## **Access Compliance Report Public Rights-of-Way** (Curb Ramps)

Intersection ID: 10024487 Main Street: CROWN\_CENTRE\_DR **Cross Street: N/A** Location: W ADA ID: 898147DA12D4 Ramp Type: PerpDiag Initial Pass/Fail: Fail **Overall Compliance: No Severity Score:** 10

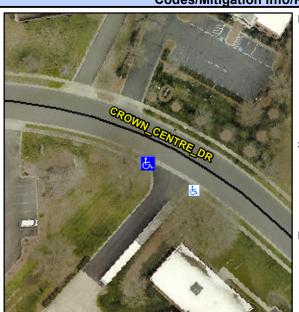
Possible Solutions: **Remove & Replace Curb Ramp With** Two New Directional Ramps or Equivalent. Surveyor Notes: N/A PROW/ADA: Not Found, R304.5.1, R304.5.3

Field Measurements/Component Compliance					
Compliance Description		Data	Comp	liance Description	Data
N/A	Ramp Length (in)	86.0	Yes	Ramp Slope (%)	7.1
No	Ramp Width (in)	43.0	No	Ramp XSlope (%)	2.7
N/A	Flare Type LT	N/A	N/A	Flare Type RT	N/A
N/A	Flare Slope LT (%)	N/A	N/A	Flare Slope RT (%)	N/A
N/A	Flare Traversable LT?	N/A	N/A	Flare Traversable RT?	N/A
N/A	Landing Length (in)	N/A	N/A	DWS Provided?	N/A
N/A	Landing Width (in)	N/A	N/A	DWS Contrast?	N/A
N/A	Landing Slope (%)	N/A	N/A	DWS Length (in)	N/A
N/A	Landing X Slope (%)	N/A	N/A	DWS Full Width?	N/A
N/A	Landing Curb? (Y/N)	N/A	N/A	DWS Offset (in)	N/A
N/A	Shared Landing?	N/A			
N/A	Gutter Ponding?	N/A	N/A	Gutter Slope (%)	N/A
N/A	Gutter Lip Ht (in)	N/A	N/A	Gutter X Slope (%)	N/A
N/A	Painted X Walk1?	No	N/A	Painted X Walk2?	No
	X Walk 1 Direction	To SE		X Walk 2 Direction	To NE
N/A	X Walk 1 Width (in)	N/A	N/A	X Walk 2 Width (in)	N/A
	X Walk 1 Slope (%)	0.5		X Walk 2 Slope (%)	4.1
